March 22, 1948

TO ALL WURLITZER DISTRIBUTORS

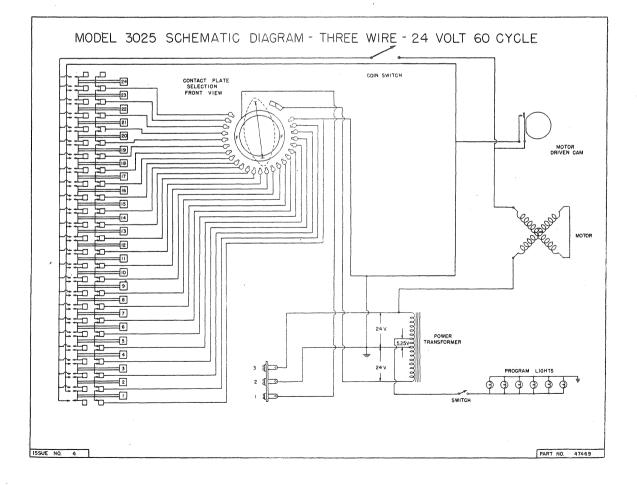
The schematic wiring diagram shown below will be followed in all future production of Model 3025 Wall Boxes. The change is in the wiring of the coin switch.

This change is easily performed in the field and is recommended in cases where complaints are received of free plays with this model wall box.
